## Stakeholder Working Group (SWG) Meeting #3 Summary

**Date:** Thursday, February 23, 2017  
**Time:** 5:30-7:30 PM  
**Location:** Four Mile Historic Park (715 S. Forest St, Denver, CO 80246)

The *Go Speer Leetsdale Mobility Study* is exploring potential improvement options for multimodal travel along the Speer Leetsdale Corridor, running approximately from Broadway and Speer southeast to Mississippi Avenue and Leetsdale (also SH 83).

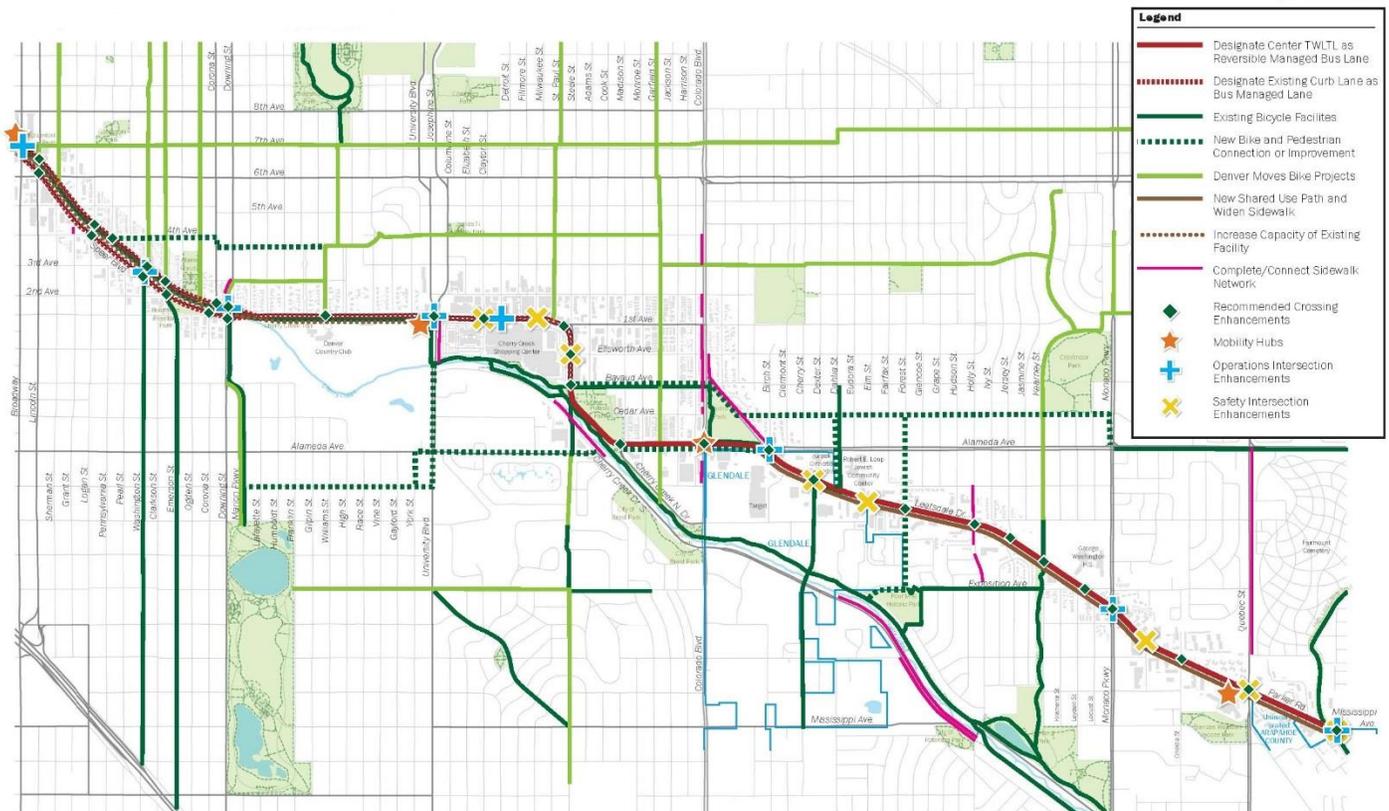
- Many Workgroup members believe the concept recommendation reflects an innovative approach and attempts to balance all primary travel modes in a limited space.

- Several Workgroup members expressed concern for possible impacts to cut-through traffic, increased vehicle travel times and a need for sensitive signage in surrounding neighborhoods.

- Of additional concern is how median use for the reversible managed lane might impact bike and pedestrian intersection crossing.
- Workgroup members were uncertain on the shape interaction would take between local and express/enhanced transit services within the managed lane.

- Specific examples of vehicular/pedestrian/bike interaction with managed transit lanes would be helpful in visualizing the concept.
- Additional information is desired on right of way constraints, any possible property acquisition and the approach to overhead electric lines.

- Current conditions show that additional cyclist and pedestrian protection is needed at bus stops.
- Consider the potential challenges of mixing bike and pedestrian travel on a shared use path. Workgroup members were concerned with safety and the relative speed of each mode of travel. Some supported a suggestion to delineate two lanes along the Chery Creek Trail with a visual divider.

- Workgroup members desired additional information to address concerns for bike connections along Garfield and interaction of the bikeway with the managed transit lane in this section of the corridor.

- Additional information will be needed on the interaction of bike, pedestrian and vehicular travel with the managed transit lane, including median use for transit stations.
- Next steps within the study process should consider possible impacts of the transit managed lanes on cut-through traffic and vehicular travel time.
- Overall, there is general support for the innovative approach reflected in the concept recommendations. The concept package presents opportunities to meet future transportation needs and integrate multi-modal travel throughout the corridor.
- The project team should remain aware of other ongoing projects within the corridor and surrounding area, particularly in regards to Cherry Creek and Denveright planning efforts.

- In next steps, further modeling on travel time savings will need to be done. A request was made for modeling that examines the potential impact of increased transit frequency. Project team members noted coordination with RTD is ongoing.
